Addendum No. 2

Bid Call No. T2023-301

**ROOF TOP UNITS AND HOT WATER TANK REPLACEMENT AT BRAMPTON
PROVINCIAL OFFENCES COURT**

ADDENDUM NO.: **M-02** ISSUED BY: **Chris Pappas**

M-801

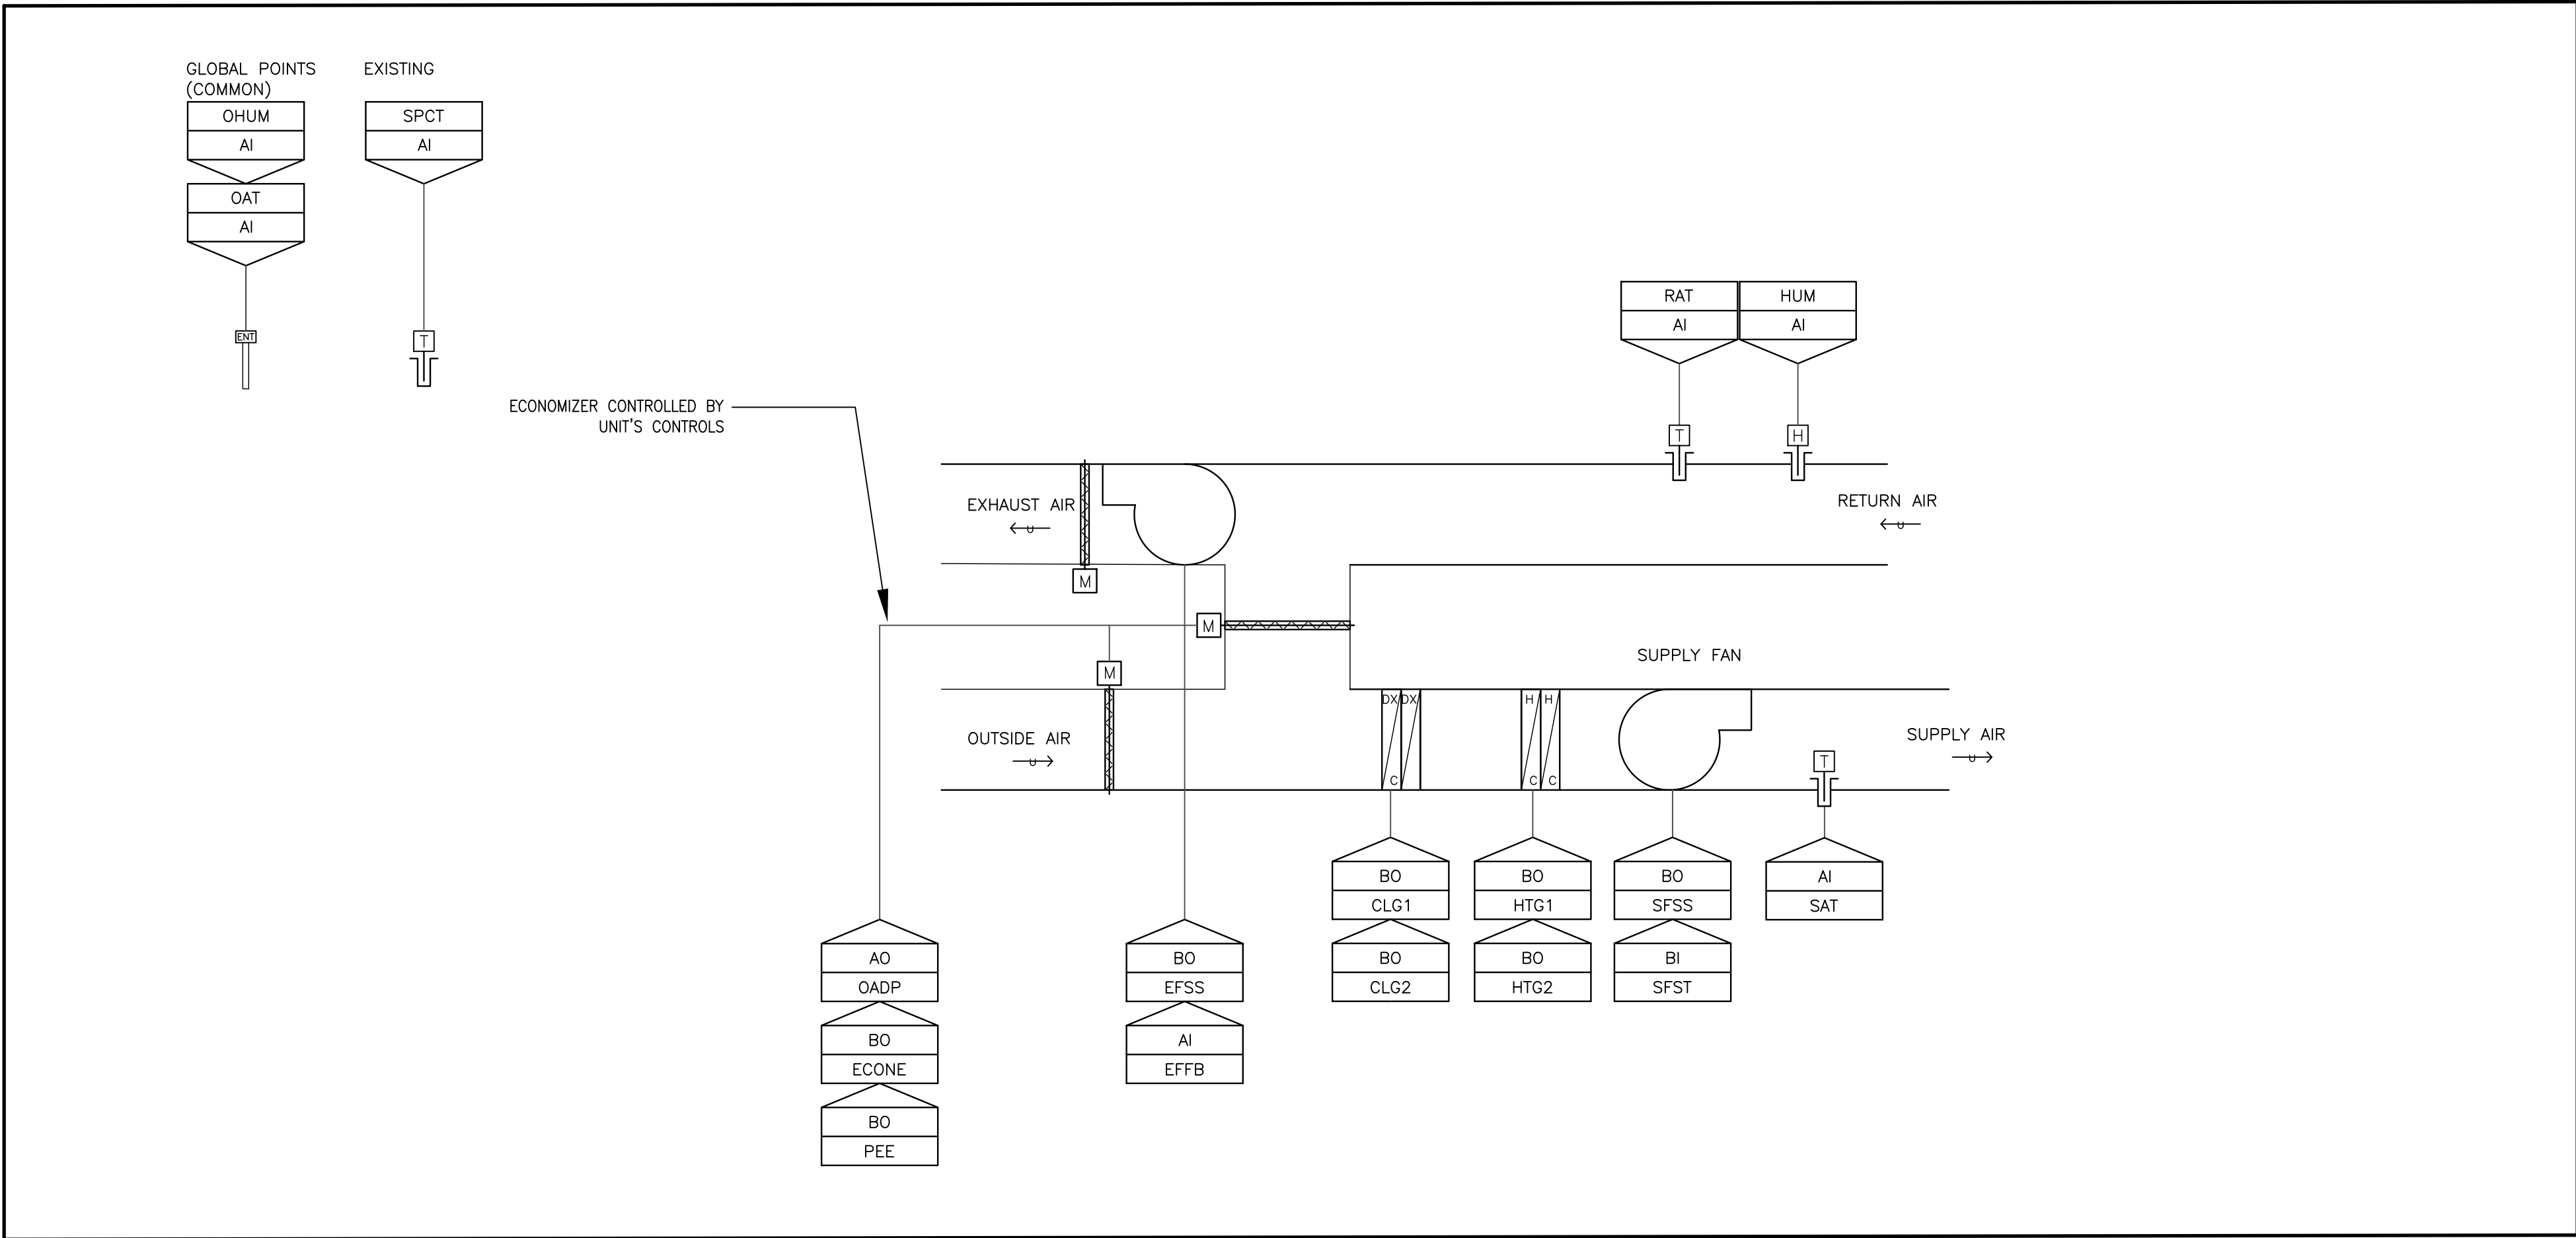
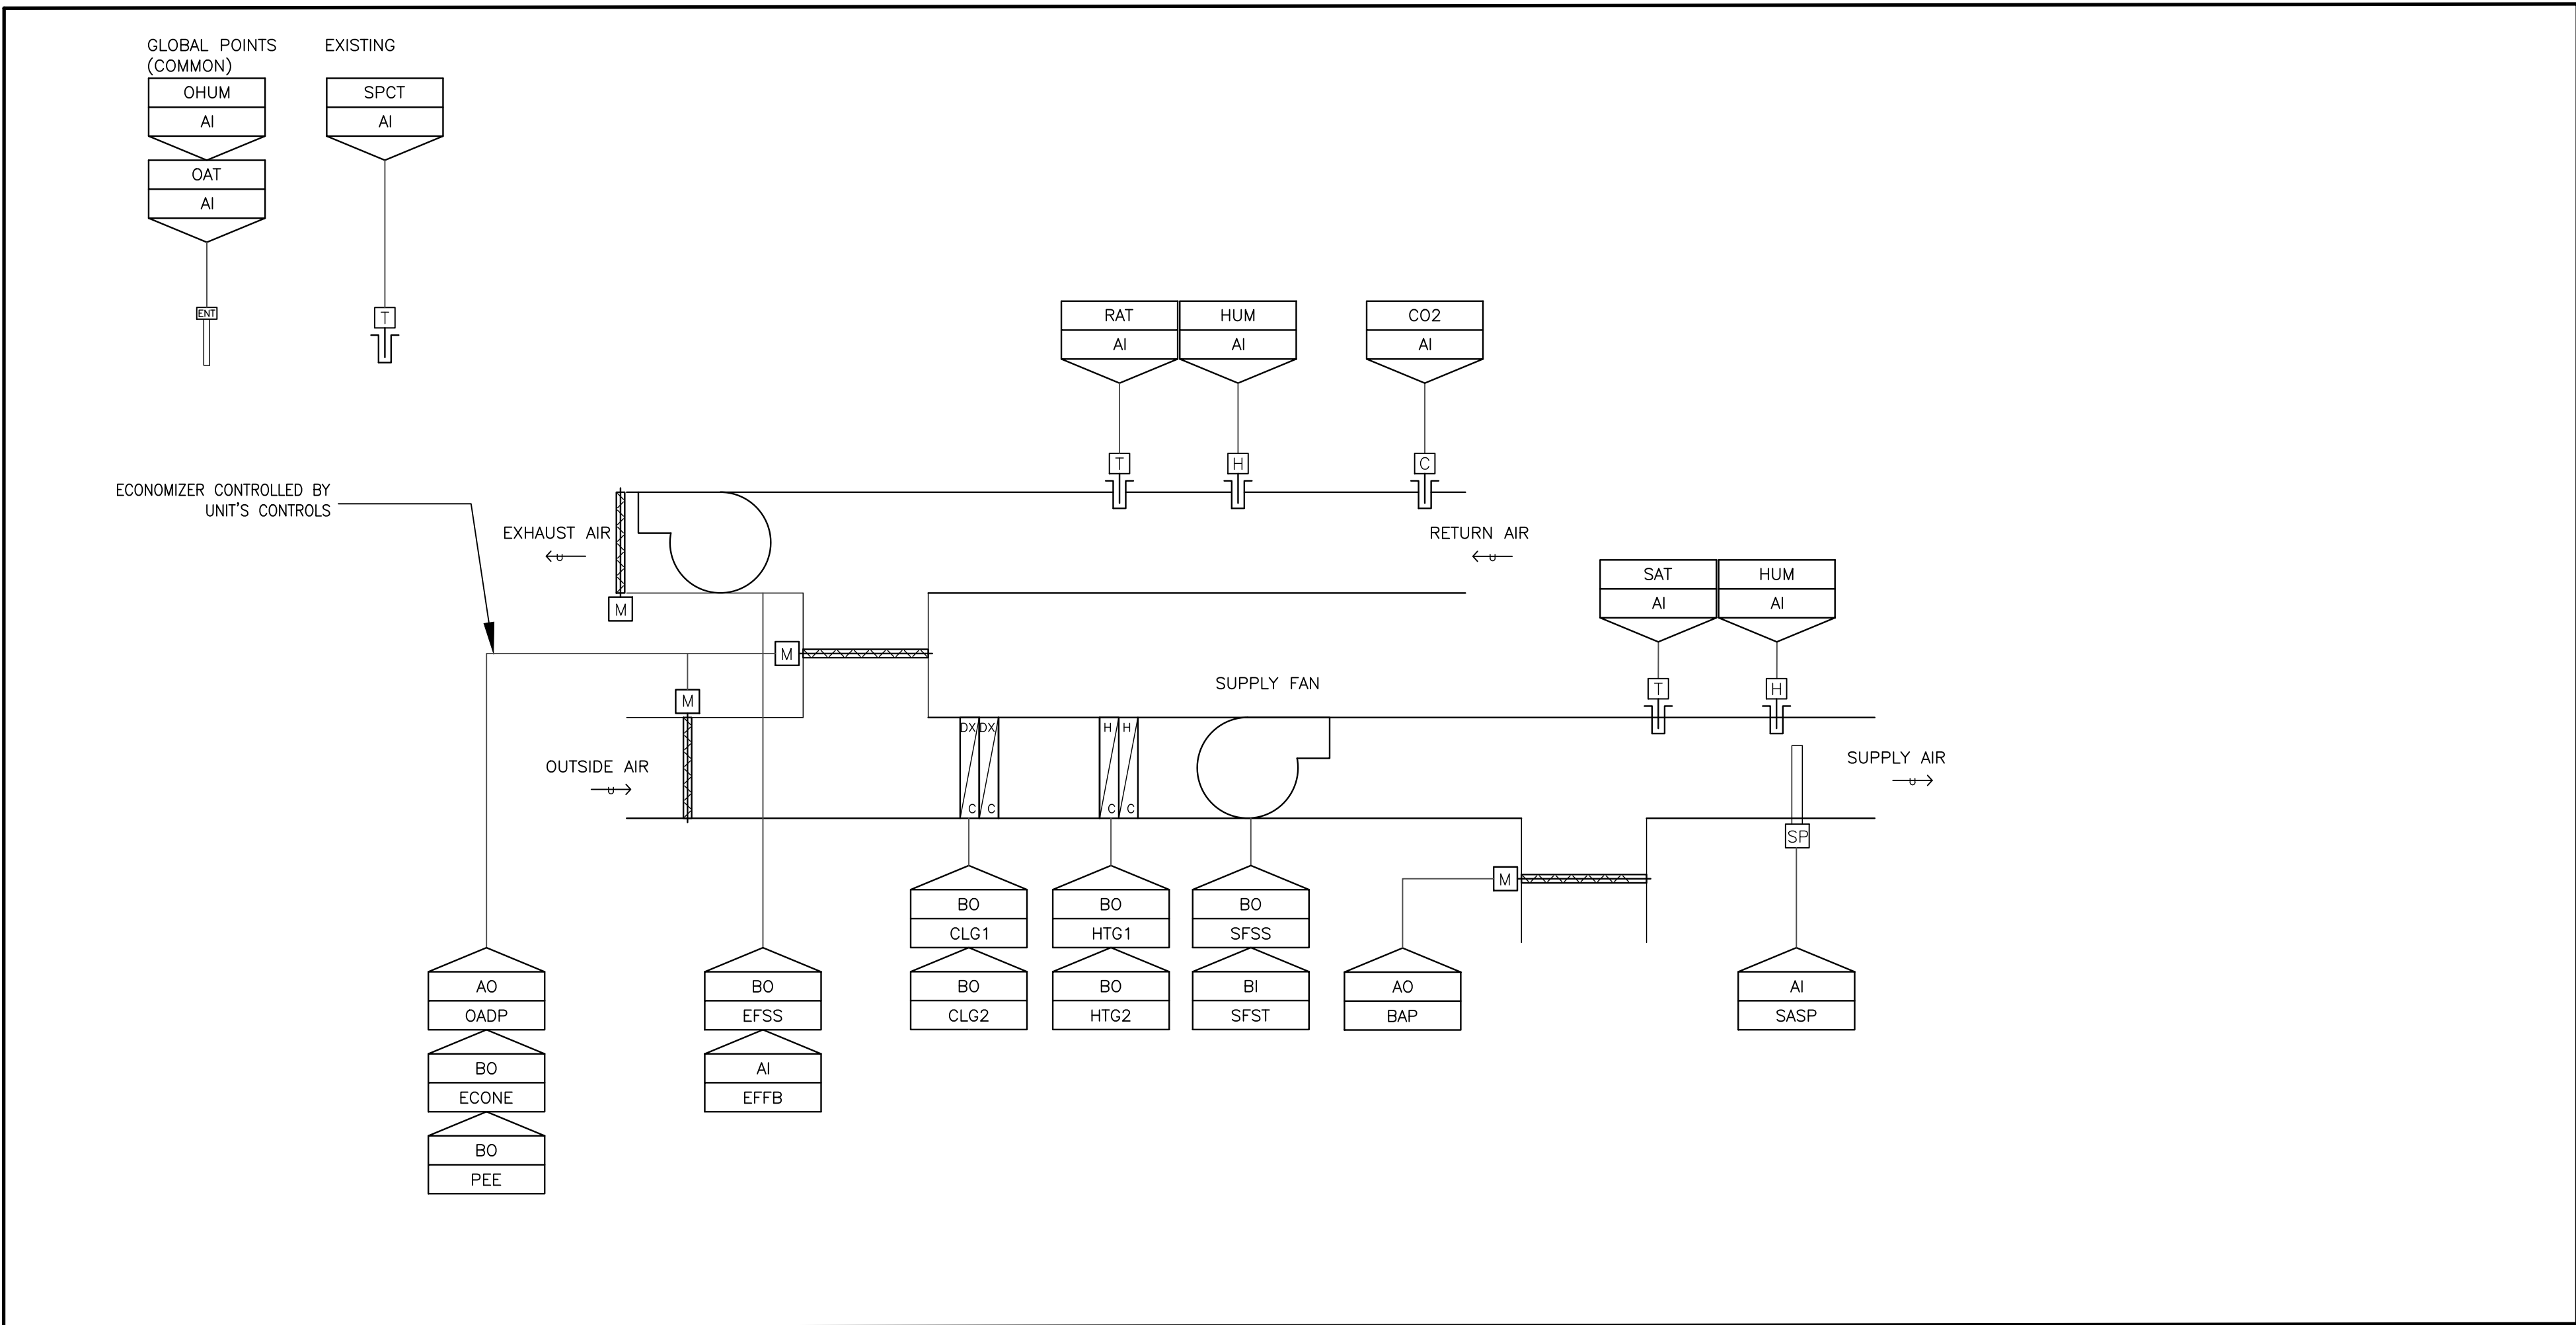
1.1 Refer to Drawing M-800 and M-801 – CONTROLS SCHEMATIC (attached herein)

1.1.1 Replace existing Drawings M-800 and M-801 with attached drawings. Changes to controls points made to drawings.
